# CITY OF ALBUQUERQUE

RE: **Silver Star Auto Haus**  
**5111 Wilshire Ave. NE**  
**Engineer's Stamp Date: 3/19/2018**  
**Hydrology File: C17D014A1**

Based on the information provided in the submittal received on 3/20/2018 the above-referenced Grading and Drainage Plan cannot be approved for Site Plan for Building Permit until the following comments are addressed.

## SITE DETAILS

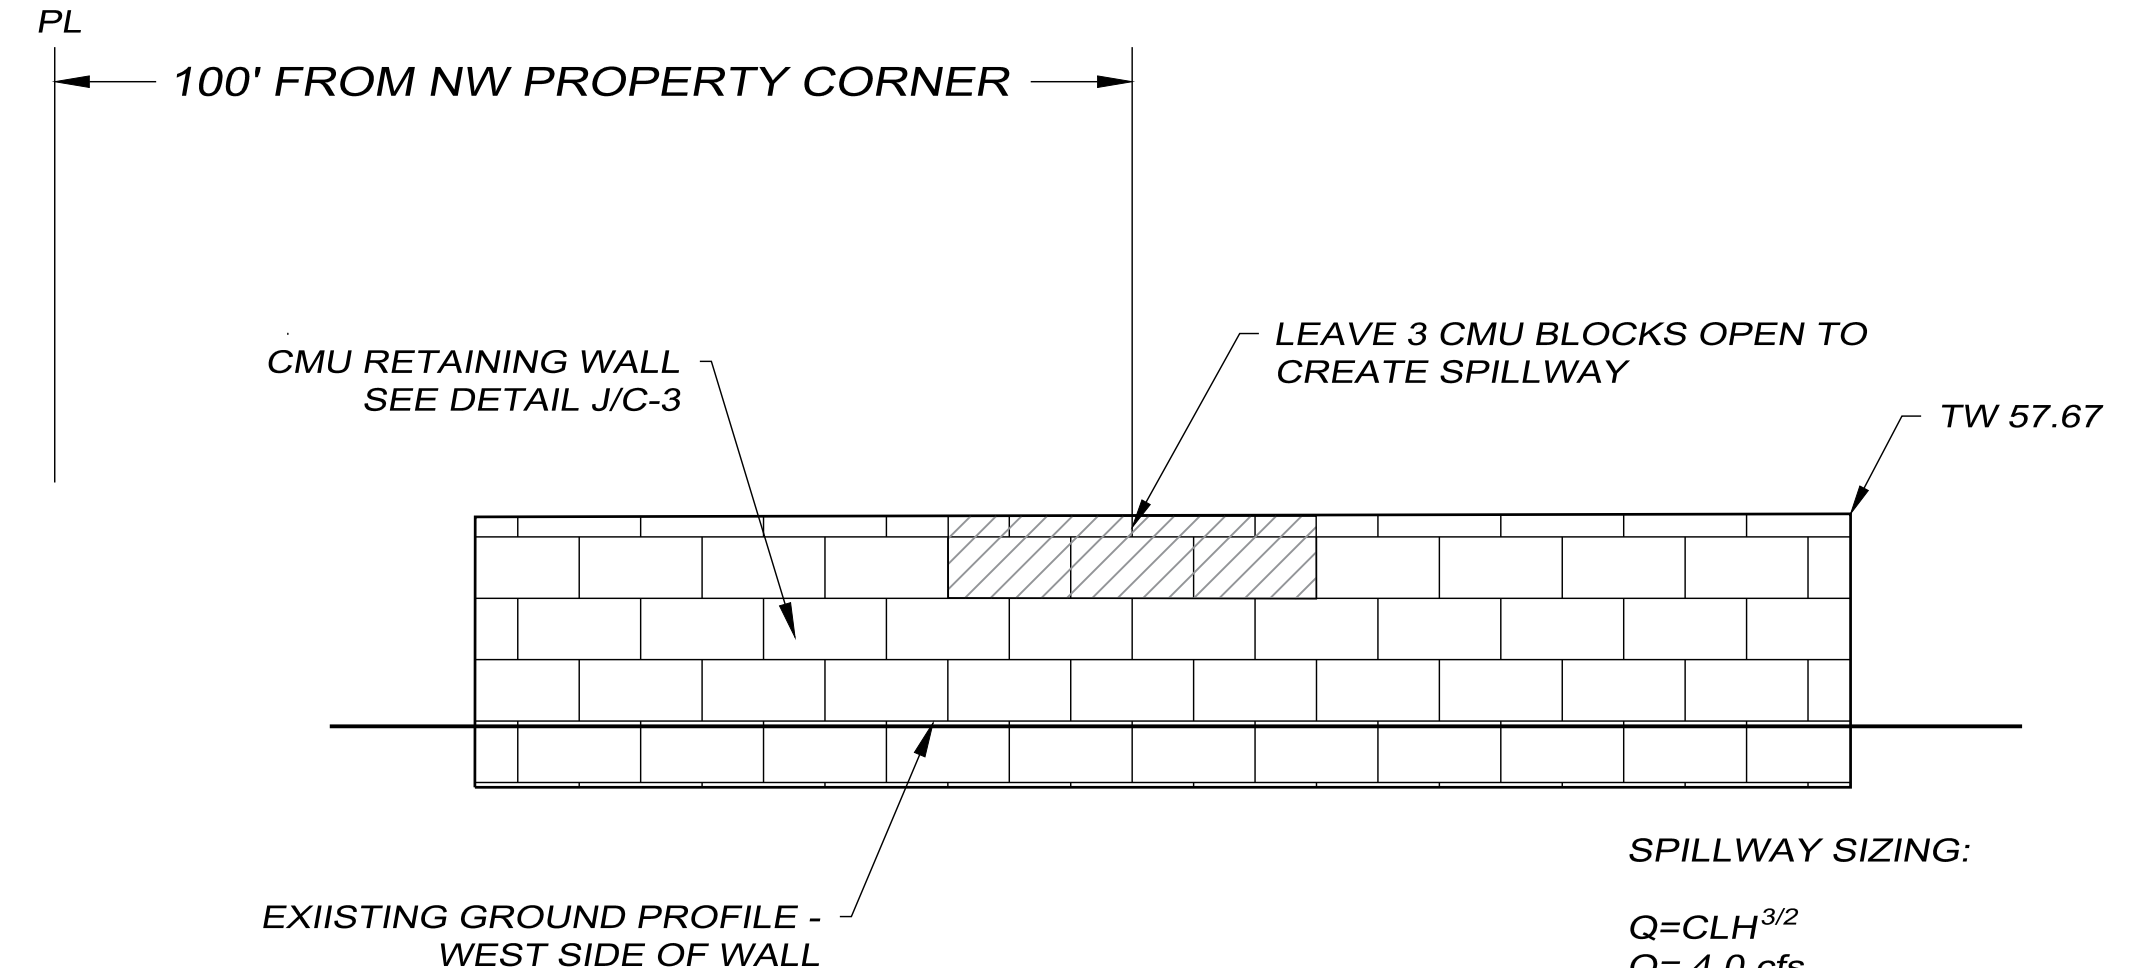
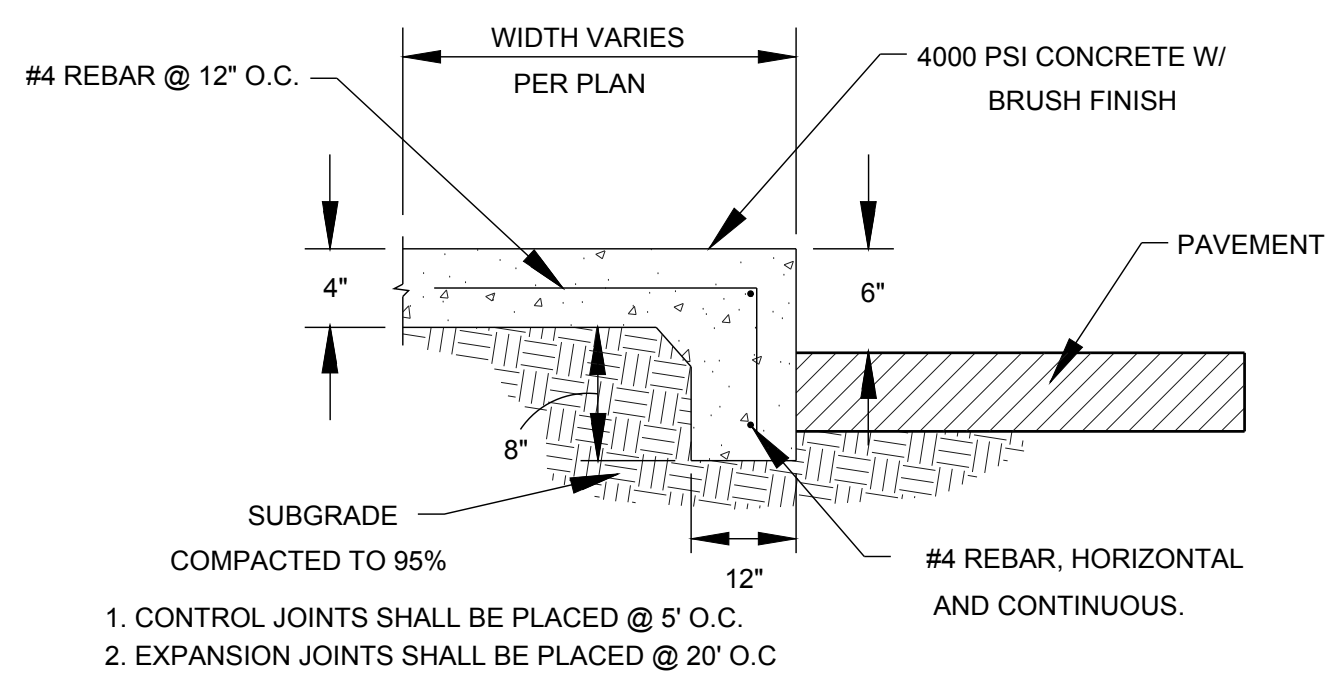
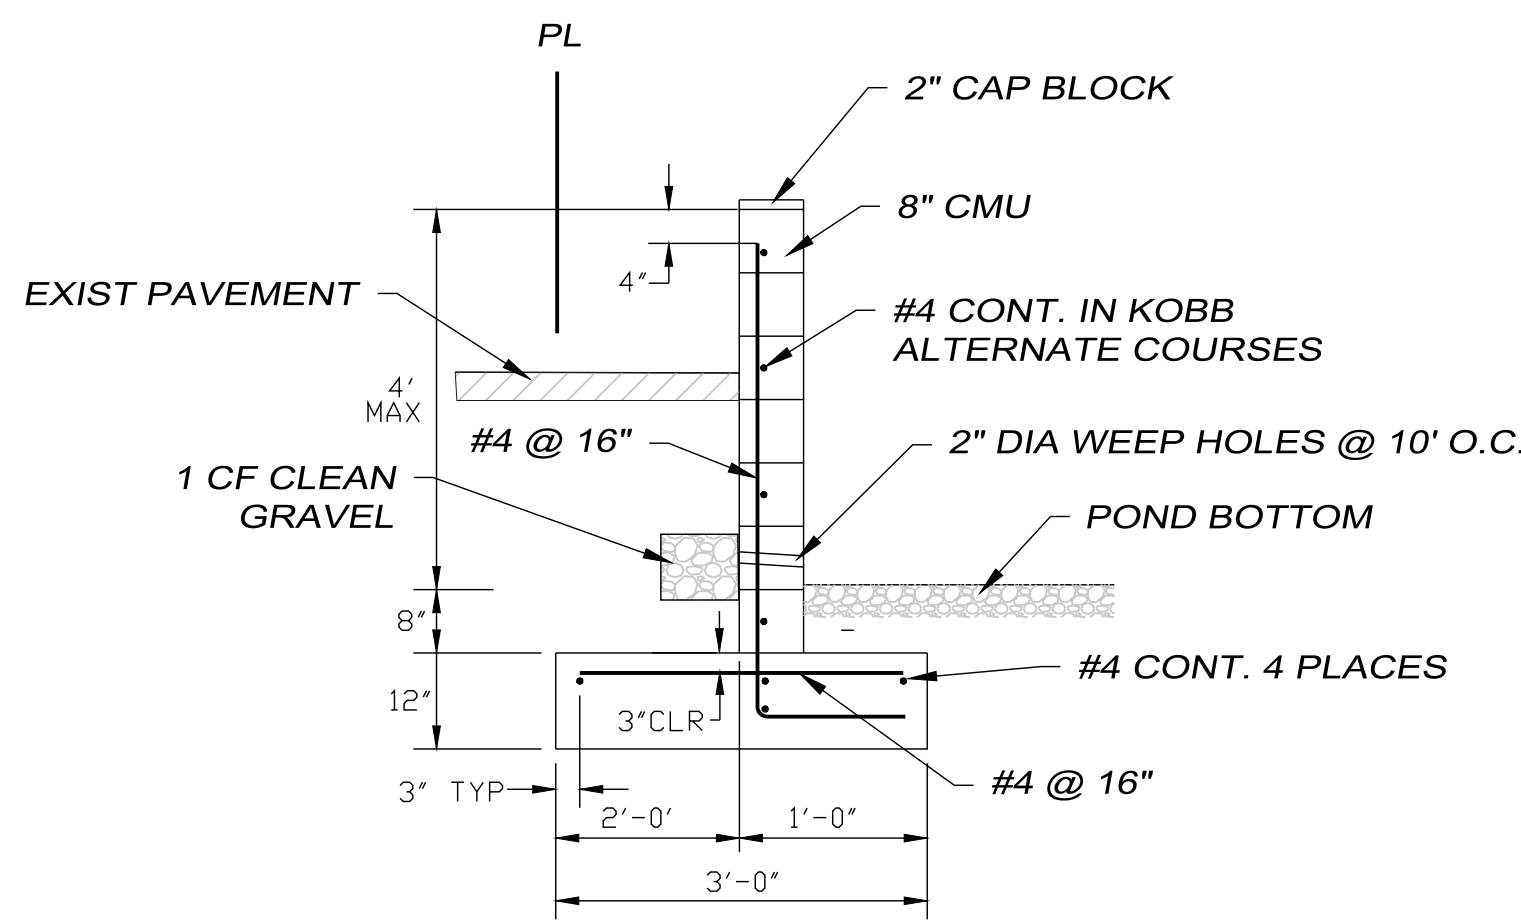
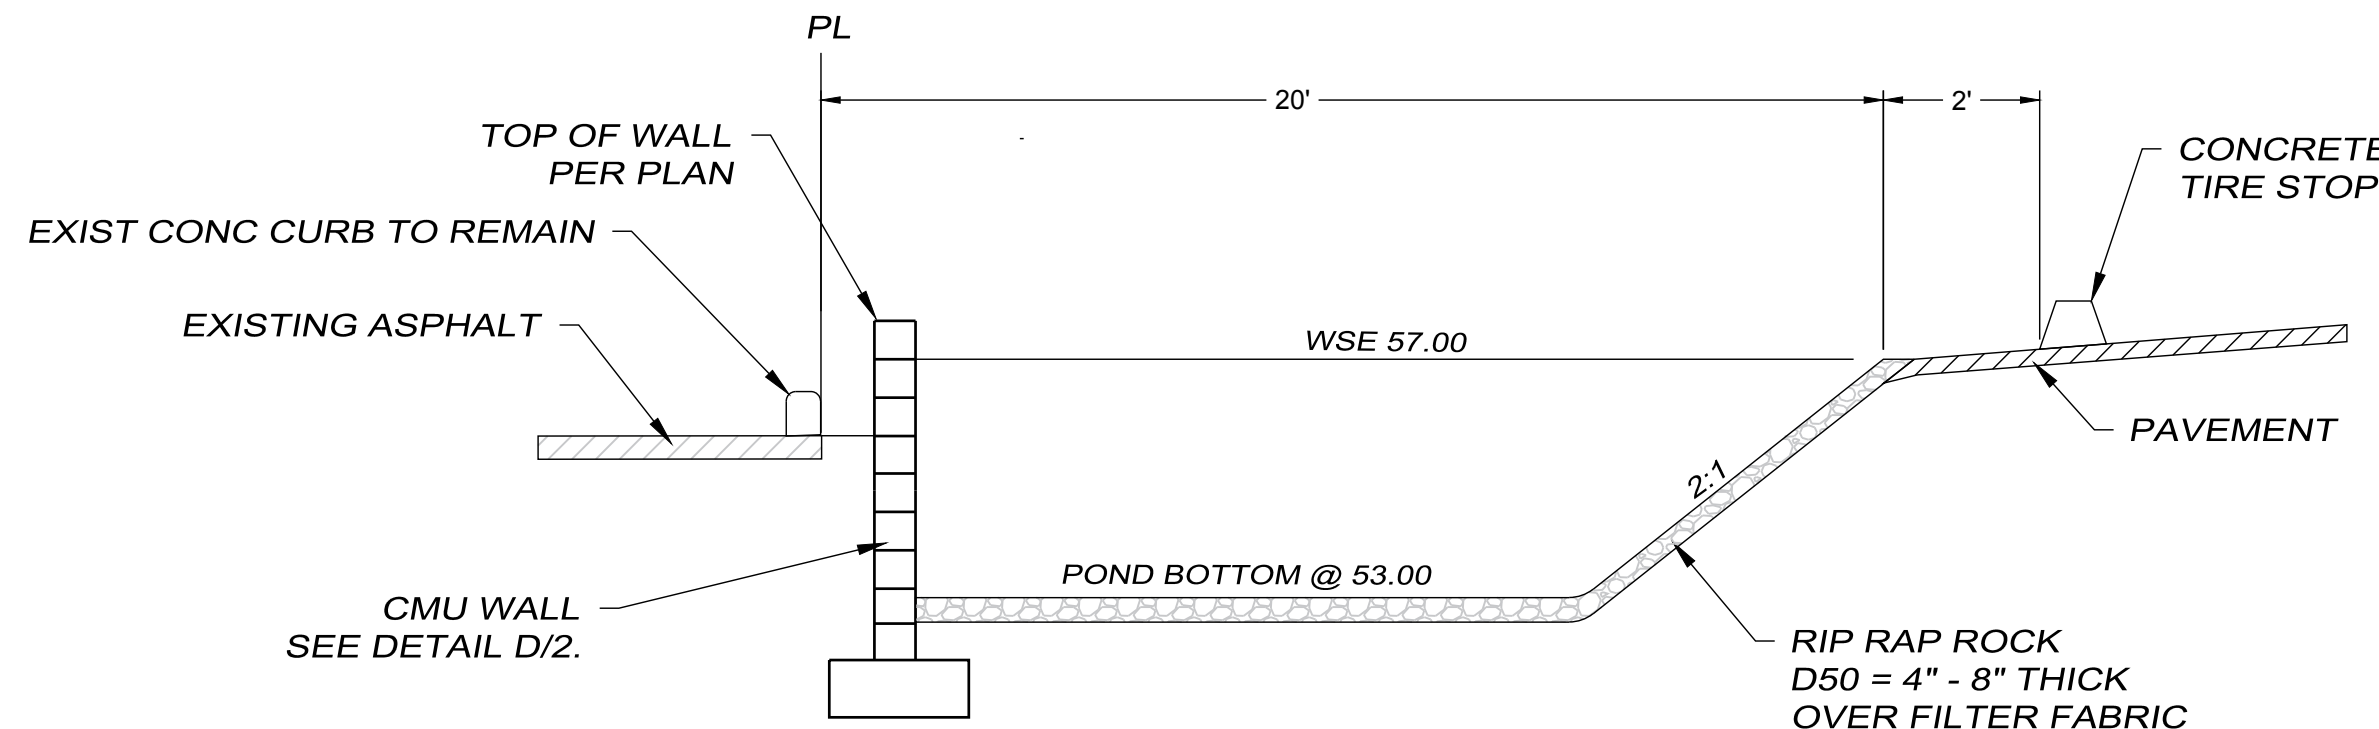
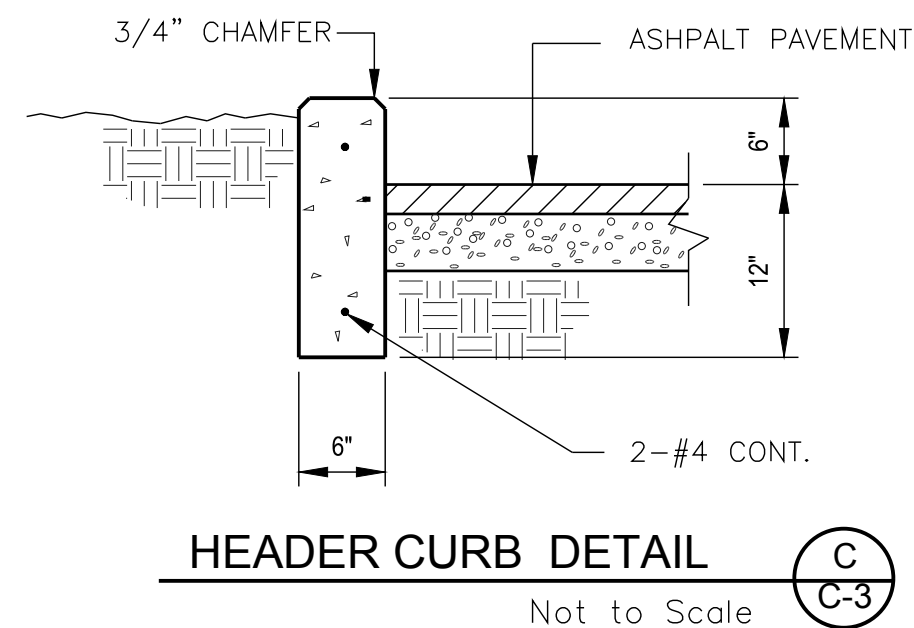
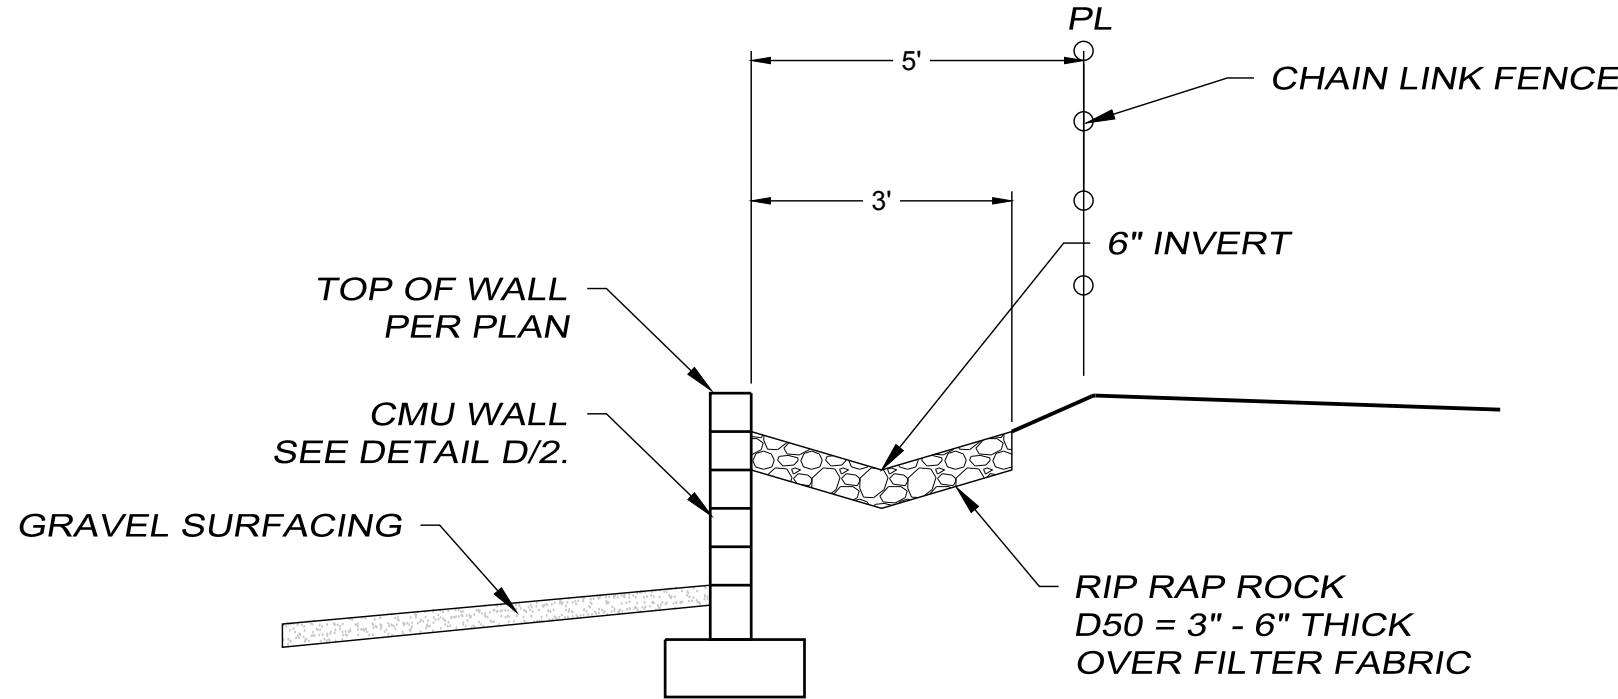
3. More information is needed on the typical sections thru the retaining walls on the west and east sides of the site to insure compliance with DPM 22.5.B "Care should be taken to ensure that existing foundations, retaining walls, stable slopes or other structures are not endangered and that the adjacent property is not damaged or its use constrained due to grading at or near the property line." Specifically dimensions should be added to the typical sections showing the maximum retained height of fill across the wall and horizontal dimensions from the property line to the closest edge of the footer as necessary to keep the footer out of the soil friction plain.
